PCN-20210615 TE0820-04 eMMC Change and Product Update

Company	Trenz Electronic GmbH
PCN Number	PCN-20210615
Title	TE0820-04 eMMC Change and Product Update
Subject	BOM change
Issue Date	2021-07-22

Locate eMMC (U6) on bottom side of PCB:

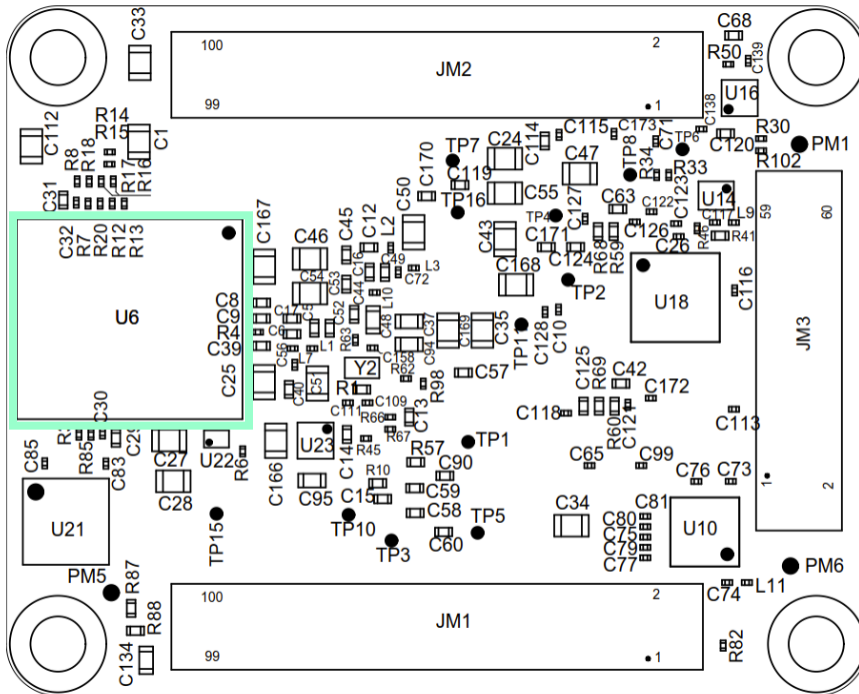
#1 Change eMMC (U6) from IS21ES08G-JCLI / IS21ES64G-JCLI to SDINBDG4-8G-XI2 / SDINBDG4-64G-XI2

Reason: Distributor informed about unforeseeable immediate EOL of parts. No official documents from manufacturer are available. No LTB, already confirmed orders were cancelled by distributor/manufacturer.

Impact: None. Replacement has same capacity as used on corresponding affected variant. Reference designs for vivado versions 2019.2 and 2020.2 were tested and work properly without any changes.

old	new
IS21ES08G-JCLI or IS21ES64G-JCLI	SDINBDG4-8G-XI2 or SDINBDG4-64G-XI2
